PROJECT:	LCE-APP-10
PART NUMBER:	80000116
ASSEMBLY NAME:	Zoom SDK Application Kit
SCHEMATICS:	ECR

TitleZoom SDK Application Board

SizeCNumber80000116RevL

| Design Create Date = Monday, July 01, 2002 | Project LCE-APP-10 | Sheet 2 Of 12 |

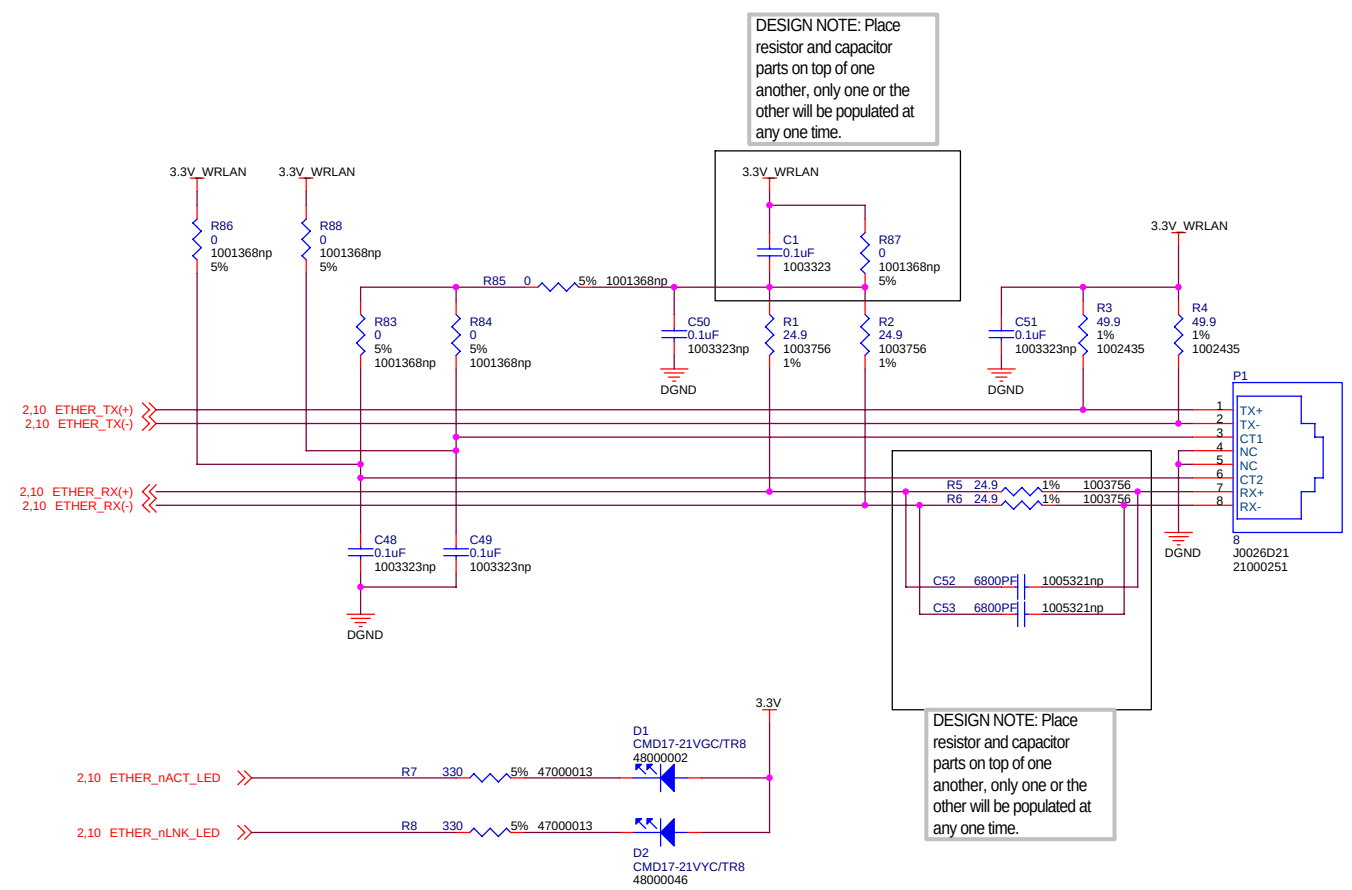
REVISIONS C->D:

1. CHANGED NETS
A39 - TOUCH_TOP (was TOUCHX2)
A38 - TOUCH_BOTTOM (was TOUCHX)
A37 - TOUCH_RIGHT (was TOUCHY2)
A36 - TOUCH_LEFT (was TOUCHY)

2. REMOVED THE NET CF_RDYnBSY AND RENAMED
THE NET RSVD 1

REVISIONS D-&gt;E:

1. CHANGED NET NAME OF uP\_NMI (J1C.21) TO uP\_NMI - WAKEUP TO ACCOMMODATE THE a400 AND A404

REVISIONS I-&gt;J:

1. Changed pin 61 of SODIMM from 3.3V to 3.3V\_uP\_BATT.

REVISIONS B-&gt;C

1. SEPARATED THE 3.3V AND 3.3V\_U<sub>P</sub>\_SDRAM ON PINS 61-64 OF THE SODIMM CON.
2. ADDED 3.3V\_VRLN TO THE DIMM CONNECTOR J1C.19
3. CHANGED NET NAMES TO FOLLOW NEW NAMING CONVENTION SHOWING ACTIVE LEVEL I.E. MSTR\_RST -> MSTR\_!RST.
4. ADDED SIGNAL\_U<sub>P</sub>\_RTCK TO MFG38 FROM THE 20PIN JTAG HEADER
5. SWITCHED THE PINS ON J1C THAT NETS LCD\_PSAVE AND LCE\_REV GO TO
6. RENAMED NET LCD\_CLKIN -> LCD\_CLK\_RETURN AND NET LCD\_CLKOUT -> LCD\_DCLK
7. REMOVED R22

REVISIONS A-&gt;E

1. CHANGED DIRECTION OF NETS LCD\_CLKIN AND LCD\_CLKOUT
2. CHANGED THE NAMES OF THE LCD DATA LINES
3. CHANGED THE NET NAMES OF EVB1 AND EVB2 TO CF\_nCE AND CF\_BSYnRDY RESPECTIVELY

REVISIONS J-&gt;L

1. Changed Net uP\_UARTB\_DSR to uP\_UARTB\_RTS

| Design Create Date = Monday, July 01, 2002 |                 | Sheet 5 Of 12      |       |

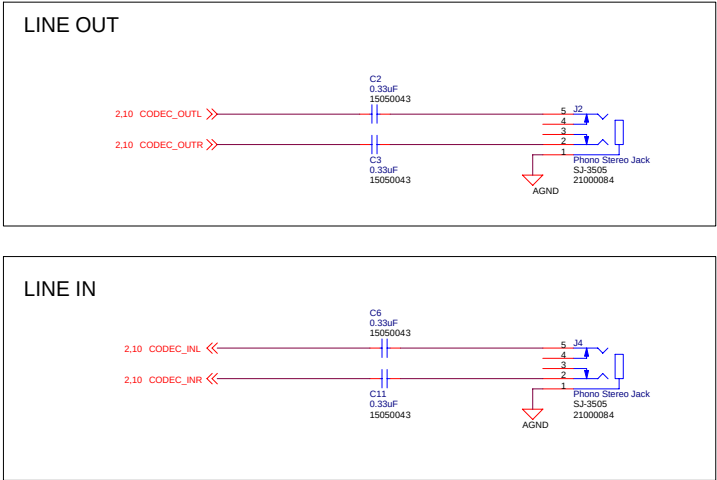
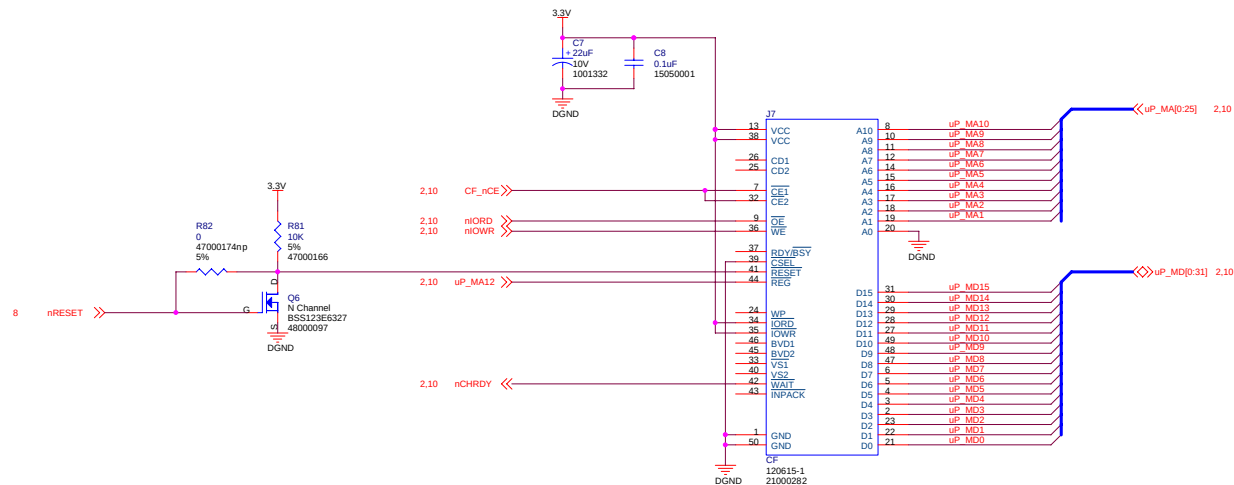
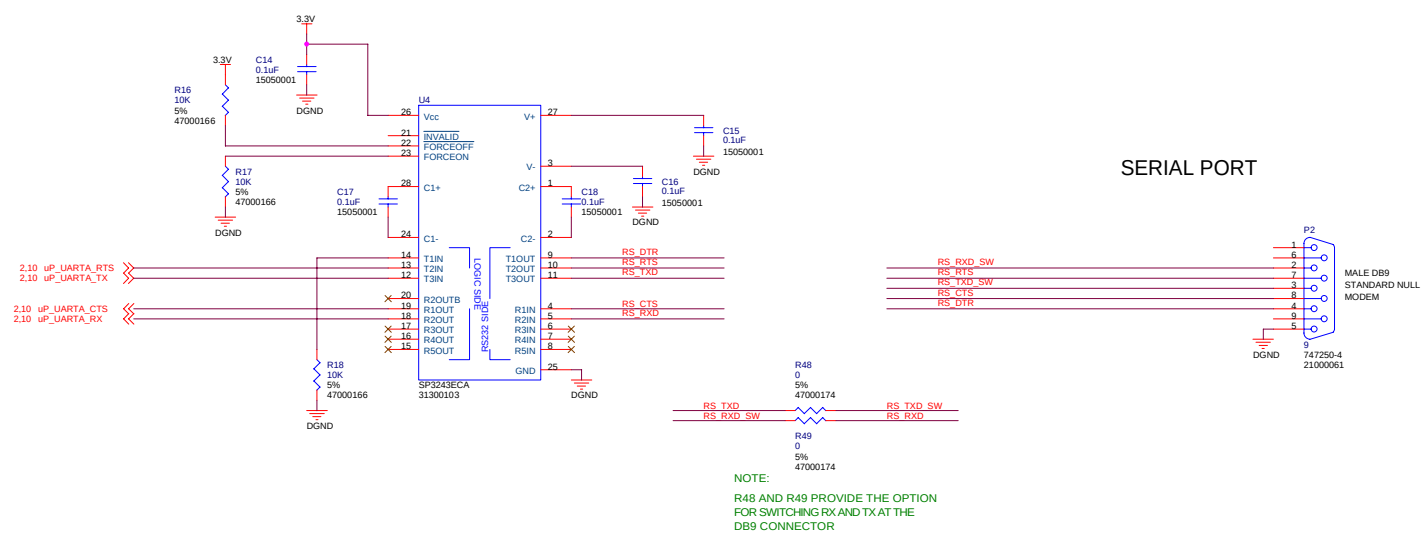
## REVISIONS I->J:

CHANGED CF RESET FROM MSTR\_nRST TO nRESET

## REVISIONS H->I:

CHANGED C7 TO 1000014 (WAS 15150011)

## REVISIONS G->H:

1. INVERTED RESET SIGNAL TO CF CARD THIS SIGNAL IS ACTIVE HIGH  
REVISIONS F->G:

1. REMOVED A0 FROM CF CONNECTOR FOR COMPATABILITY WITH  
A400 BSC IN A 16BIT AREA

## REVISIONS C->D:

1. CHANGED NET THAT CONNECTS TO REG ON J7.44 FROM uP\_MA13  
TO uP\_MA12

2. REMOVED THE NET CF\_RDYnBSY

## REVISIONS B->C:

1. CHANGED NET THAT CONNECTS TO REG ON J7.44 FROM uP\_MA11  
TO uP\_MA13

2. REMOVED PULLUP ON CF\_RDYnBSY

## REVISIONS A->B:

1. ADDED NET uP\_MA3 TO J7.17 FOR 16BIT ADDRESSABILITY  
2. CHANGED NETS MFP3 AND MFP6 TO EVB1 AND EVB2

3. REMOVED NET uP\_MA0 AND TIED THAT PIN ON J7 TO GND

4. REMOVED HOT SWAPPABILITY, DELETED NETS  
uP\_PCCDRY AND CF\_3.3V, AND COMPONENTS Q1, C10

5. ADDED ADDRESS LINES uP\_MA0,4-9 AND uP\_MA11 FOR  
GREATER FUNCTIONALITY AND USABILITY OF MORE CF CARDS

6. CHANGED THE NET NAMES OF EVB1 AND EVB2 TO  
CF\_nCE AND CF\_BSYnRDY RESPECTIVELY

## REVISIONS J->K:

1. CHANGED C7 FROM 150uF TO 22uF

| Design Create Date = Monday, July 01, 2002 |                 | Project LCE-APP-10 | Sheet 7 Of 12 |

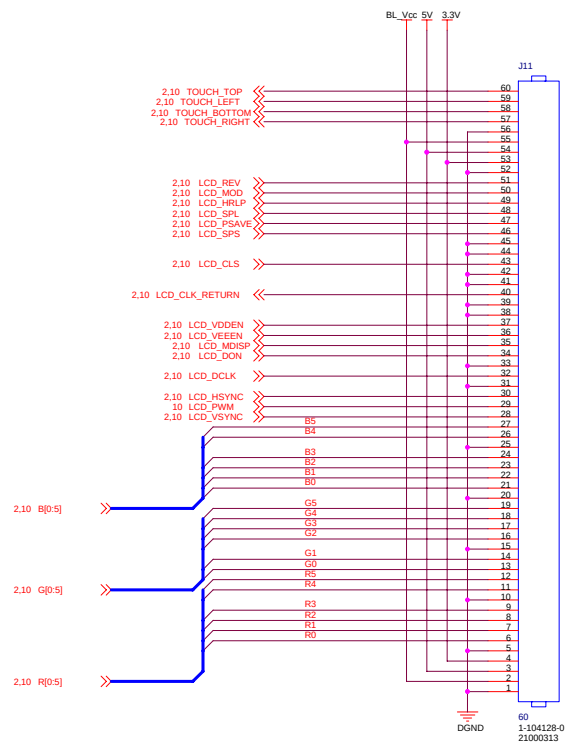
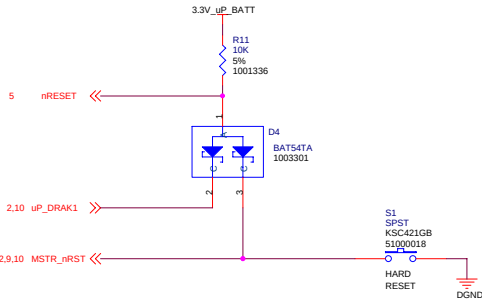
## REVISIONS C-&gt;D:

1. CHANGED NETS  
A39 - TOUCH\_TOP (was TOUCHX2)  
A38 - TOUCH\_BOTTOM (was TOUCHX)  
A37 - TOUCH\_RIGHT (was TOUCHY2)  
A36 - TOUCH\_LEFT (was TOUCHY)

## REVISIONS B-&gt;C:

1. CHANGED THE 60PIN LCD CONNECTOR J11 TO A SHROUDEDKEYEDW  
EJECTOR TABS TYPE
2. SWITCHED THE PINS ON J11 THAT NETS LCD\_PSAVE  
AND LCE\_REV GO TO
3. RENAMED NET LCD\_CLKIN -> LCD\_CLK\_RETURN  
AND NET LCD\_CLKOUT -> LCD\_DCLK

## REVISIONS A-&gt;B:

1. CHANGED DIRECTION OF NETS LCD\_CLKIN AND  
LCD\_CLKOUT
2. CHANGED THE NAMES OF THE LCD DATA LINES

| Design Create Date = Monday, July 01, 2002       | Project                    | LCE-APP-10                                                                                     | Sheet 8 Of 12 |

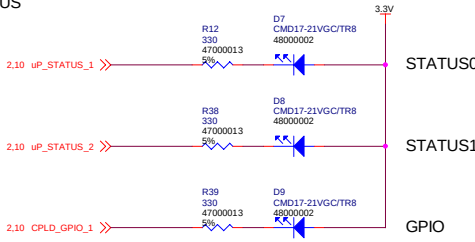
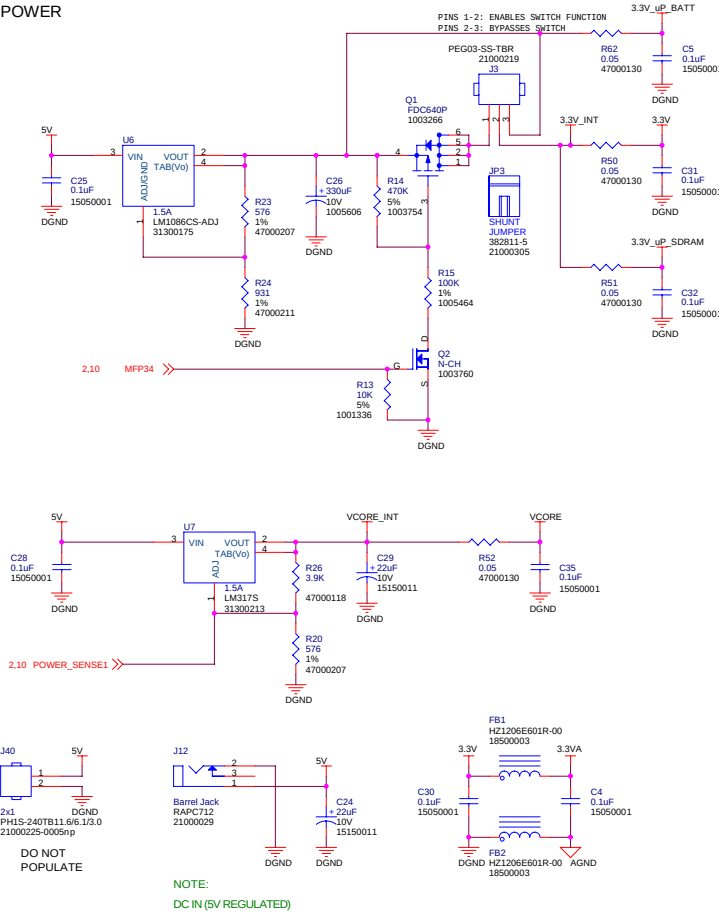
- REVISIONS I->J:
1. ADDED nRESET SIGNAL WHICH IS DIODE-OR'D SWITCH RESET AND uP\_nRESET\_OUT
  2. ADDED ON/OFF CONTROL TO 3.3V POWER SUPPLIES (AND JUMPER).

- REVISIONS H->I:
1. CHANGED C26 TO 1000014 (WAS 15150011)
  2. CHANGED S1 & S2 TO 51000018
- REVISIONS G->H:
1. MADE C27 A NO POP, DUE TO MSTR\_RST SIGNAL RISE TIME ISSUES

- REVISIONS E->F:
1. CHANGED J40 FROM BL\_VCC TO 5V AND GND
  2. MADE C36 A NO POP
- REVISIONS D->E:
1. ADDED THE CIRCUIT NMI - WAKEUP AND CHANGED NET uP\_NMI TO uP\_NMI - WAKEUP

- REVISIONS B->C:
1. CHANGED J40 FROM POPULATE TO DO NOT POPULATE
  2. SEPARATED THE 3.3V AND 3.3V\_uP\_SDRAM
  3. ADD SENSE RESISTORS AND .1uF CAPS TO THE 3 PLANES VCORE, 3.3V, AND 3.3V\_uP\_SDRAM

4. CHANGED NET NAMES TO FOLLOW NEW NAMING CONVENTION SHOWING ACTIVE LEVEL IE. MSTR\_RST -> MSTR\_nRST.
  5. CHANGED REF DES J40np TO J40
- REVISIONS A->B:

1. CHANGED THE NETS THAT CONTROL THE LED'S FROM MFP11, MFP12, MFP4 TO uP\_STATUS1, uP\_STATUS2, CPLD\_GPIO1
  2. CHANGED U6 TO AN LDO REGULATOR

- REVISIONS J->K:
1. CHANGED C26 FROM 150uF TO 330uF
  2. CHANGED R14 FROM 10K TO 470K
  3. ADDED R15

| Design Create Date = Monday, July 01, 2002 | Project LCE-APP-10 | Sheet 9 Of 12 |  |

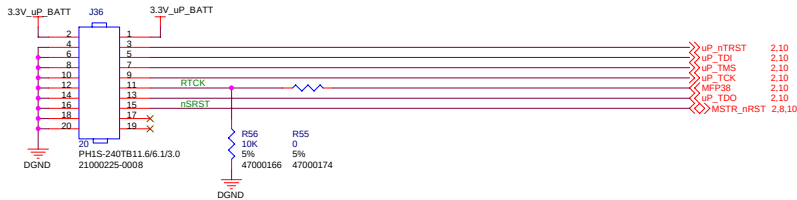
REVISIONS I->J:

1. CHANGED ARM JTAG POWER TO 3.3V\_uP\_BATT

REVISIONS F->G:

1. UPDATED JUMPER TABLE FOR NORMAL OPERATION TO INDICATE THAT THE JUMPERS SHOULD BE NOT POPULATED
2. REMOVED NOTE REGARDING 75401L RTCK AND WGLER EMULATOR

REVISIONS D->F:

1. REMOVED uP\_TEST1 FROM J15.8 AND CONNECTED TO J15.10, GROUND J15.8
2. MOVED JUMPER BLOCK J6 OFF OF CIRCUIT FOR J15 FOR CLARITY

REVISIONS C->D:

1. CHANGED STYLE OF JUMPER SETTINGS TABLE AND CORRECTED THE SETTINGS FOR THE LH75401
2. CORRECTED THE SETTINGS FOR THE LH7A400

REVISIONS B->C:

1. CHANGED J6.5, J6.6 TO GND AND REMOVED R50
2. REMOVED JTAG PULLUPS FOR THE PROCESSOR R31 - R37 THESE ARE NOW LOCATED ON ALL CARD ENGINES
3. REMOVED JTAG PULLUPS FOR THE CPLD R43 - R46 THESE ARE NOW LOCATED ON ALL CARD ENGINES
4. CHANGED J36 TO A 20PIN CONNECTOR FOR THE ICE STANDARD 20PIN JTAG
5. ADDED SIGNAL uP\_RTCK TO MFP38 FROM THE 20PIN JTAG HEADER
6. CHANGED REF DES J41np TO J41

REVISIONS A->B:

1. CHANGED R34 TO A CONFIG RESISTOR. THIS WILL ALLOW THE SHARP ENGINE TO SWITCH BETWEEN JTAG MODE AND NORMAL MODES OF OPERATION.
2. DELETED CONFIGURATION RESISTORS R34, R37 AND ADDED A JUMPER BLOCK TO SWITCH BETWEEN JTAG MODE AND NORMAL MODE.

|                                                                                       |   |                                            |          |                                                                                                 |  | Sheet 10 Of 12 |       |

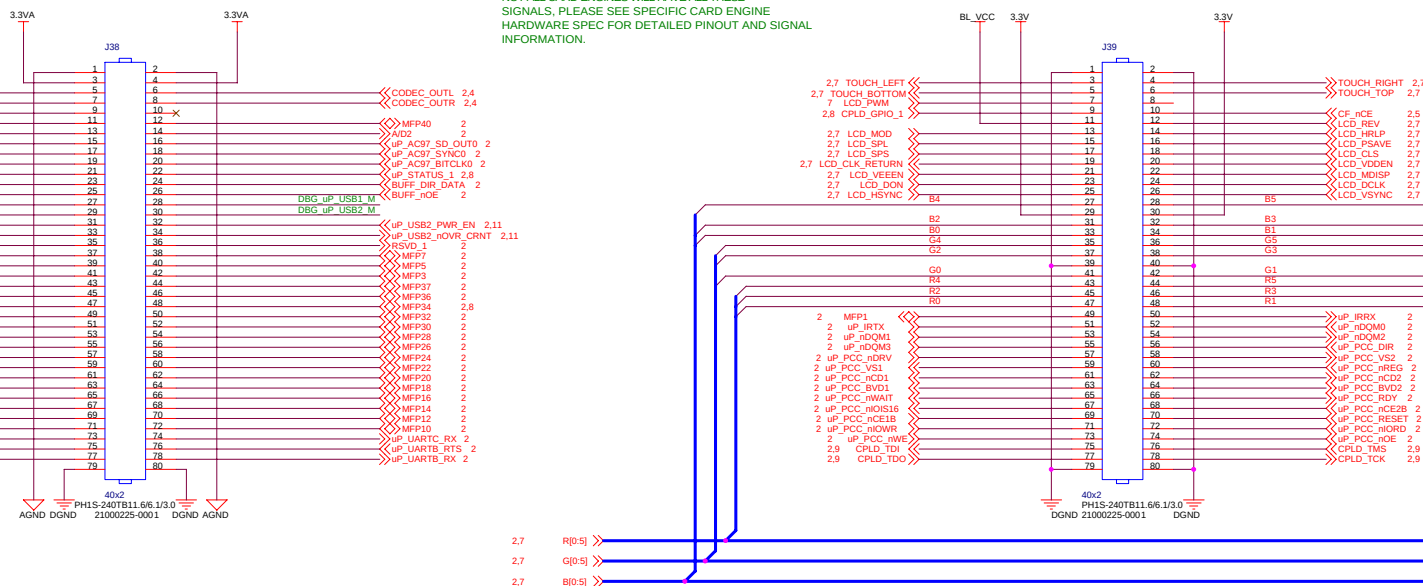
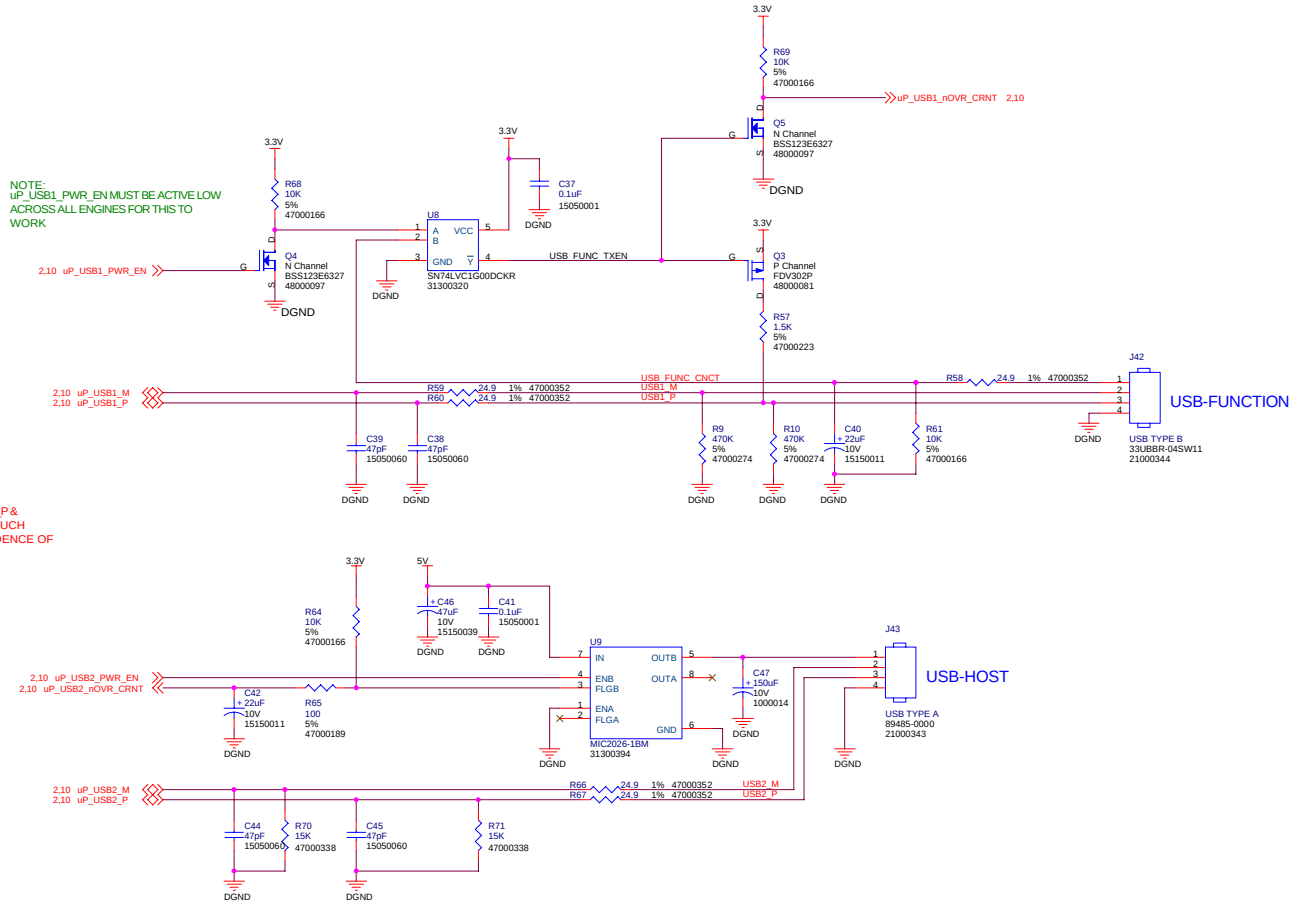
REVISIONS C-&gt;D:

1. CHANGED NETS  
A39 - TOUCH\_TOP (was TOUCHX2)  
A38 - TOUCH\_BOTTOM (was TOUCHX)  
A37 - TOUCH\_RIGHT (was TOUCHY2)  
A36 - TOUCH\_LEFT (was TOUCHY)  
2. REMOVED THE NET CF\_RDYNBSY AND  
RENAMED THE NET RSVD\_1

### E REVISIONS D->E:

1. CHANGED NET NAME OF uP\_NMI (J16.12) TO MuP\_NMI - WAKEUP TO ACCOMODATE THE a400 AND A404.

REVISIONS E<sub>1</sub>→E<sub>2</sub>

1. ADDED R72 - R79 TO SEPARATE DIFF  
PAIRS FROM EXPANSION HEADERS

REVISIONS B-&gt;C

1. ADDED TERMINATIONS TO uP\_AUX\_CLK AND uP\_BUS\_CLK
2. CHANGED NET NAMES TO FOLLOW NEW NAMING CONVENTION SHOWING ACTIVE LEVEL IE. MSTR\_RST -> MSTR\_nRST.
3. RENAMED NET LCD\_CLKIN -> LCD\_CLK\_RETURN AND NET LCD\_CLKOUT -> LCD\_DCLK

4. SWITCHED THE PINS ON J39 THAT NETS LCD\_PSAVE AND LCE\_REV GO TO
5. CHANGED REF DES OF R53np, R54np, C33np, C34np TO R53, R54, C33, C34
- REVISIONS A->B:

1. CHANGED THE NAMES OF THE LCD DATA LINES
2. CHANGED THE NET NAMES OF EVB1 AND EVB2 TO CF\_nCE AND CF\_BSYnRDY RESPECTIVELY

REVISIONS F-&gt;L:

1. Changed Net uP\_UARTB\_DSR to uP\_UARTB\_RTS
